LEARNER LUXURY PROPERTIES

PERMIT # 000046636

High Springs Lot 7

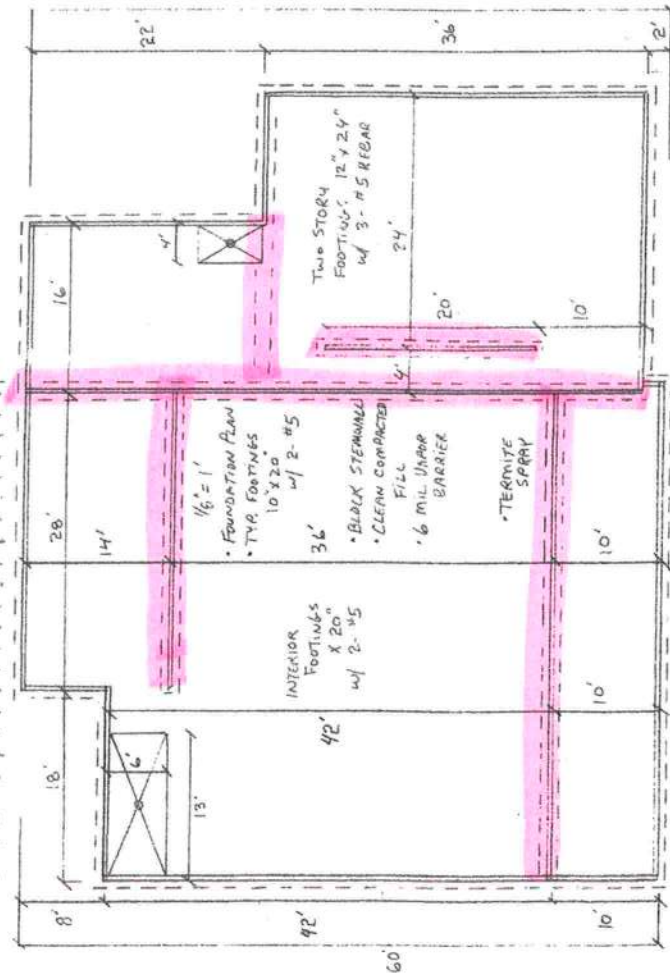
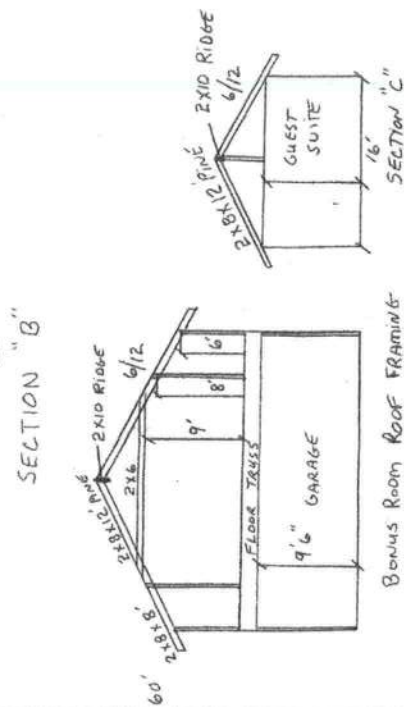
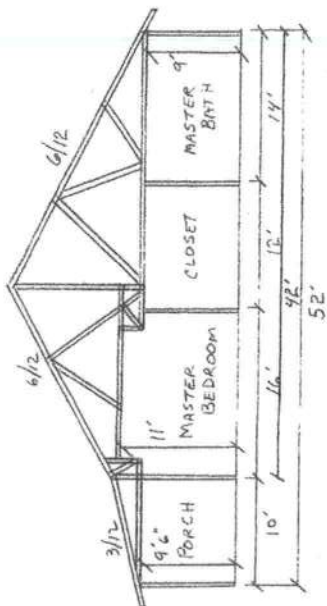
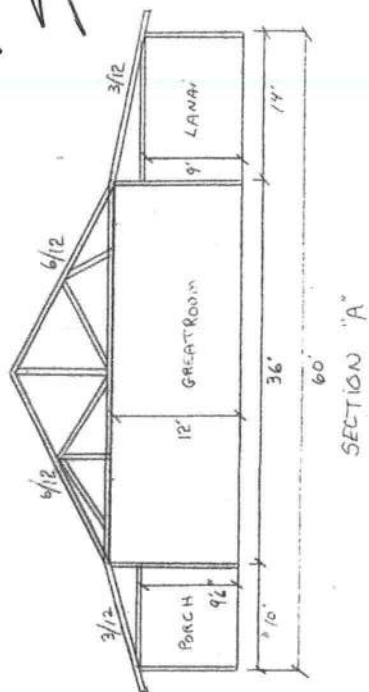
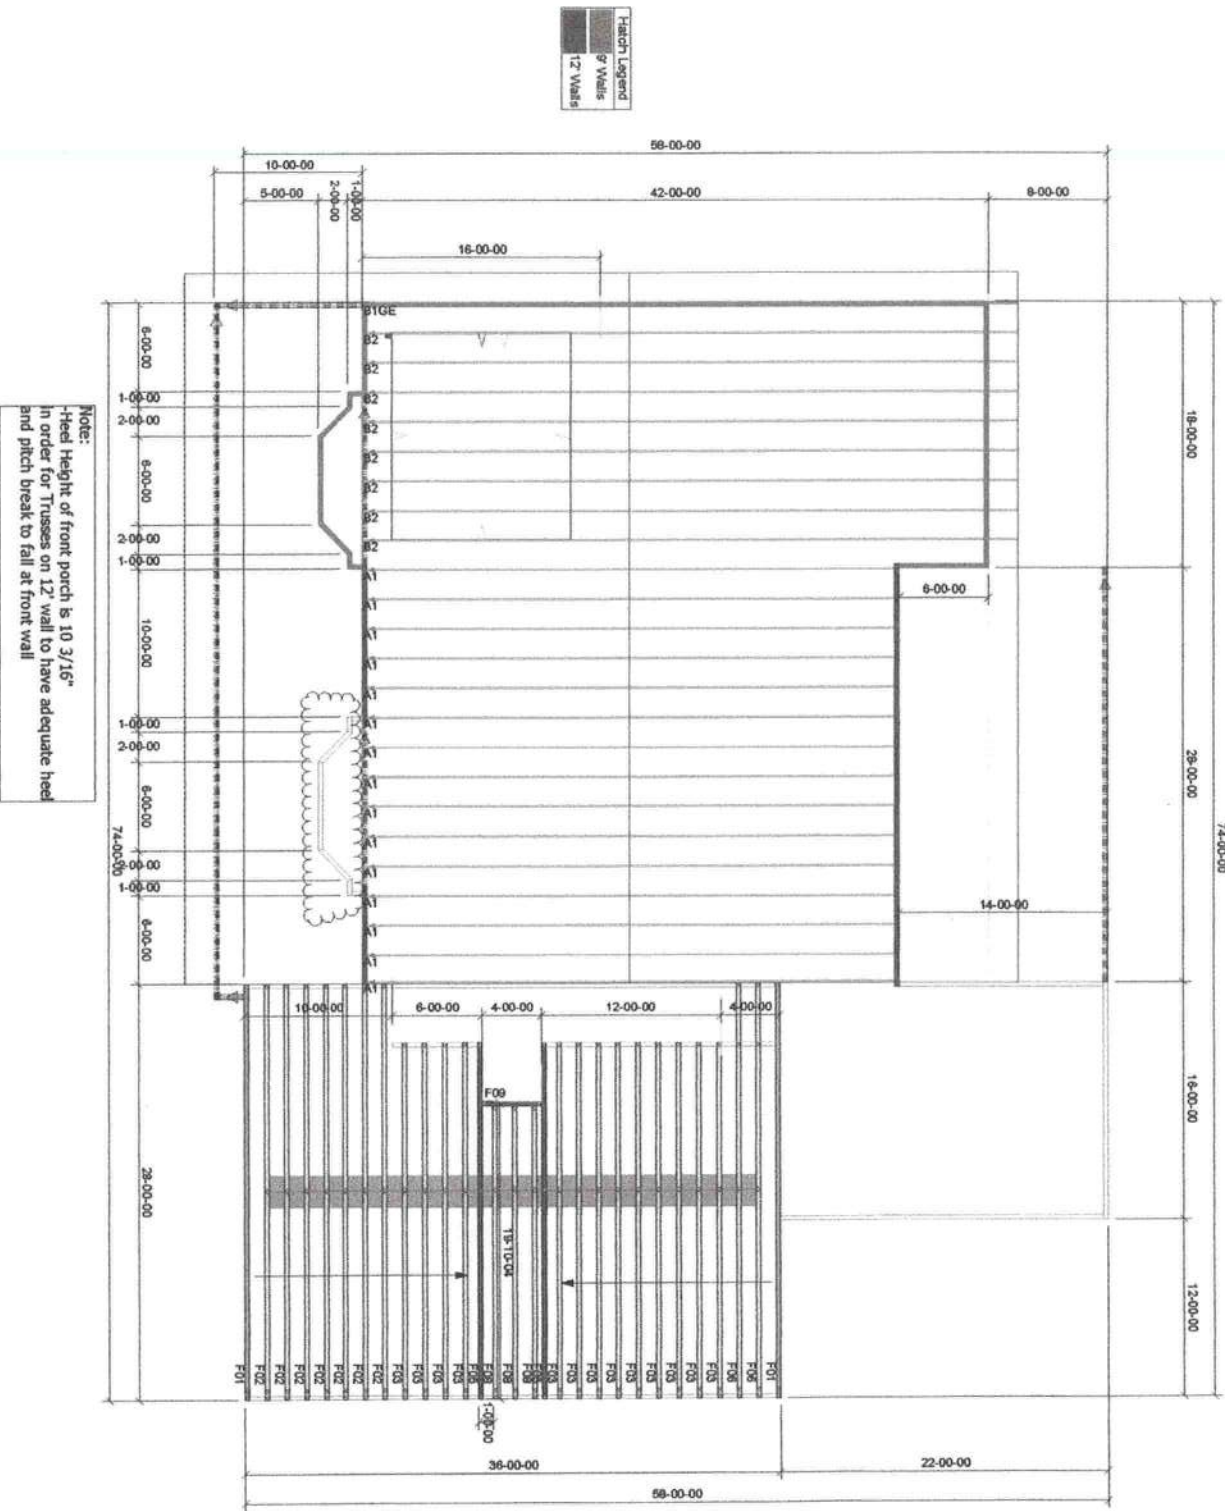
- THIS WAS THE PLAN SUBMITTED FOR INTERIOR FOOTINGS
- I FORGOT TO DELETE THEM ON MY LARGE PLAN SUBMITTED.
- TRUSSES SPAN ENTIRE DISTANCE. NO INTERIOR FOOTINGS NEEDED.
- AWAITING DYREN SURVEY TO GIVE US ELEVATION POINTS.
- AS SOON AS WE GET THEM, LANCE JONES IS READY TO SUBMIT LETTER.
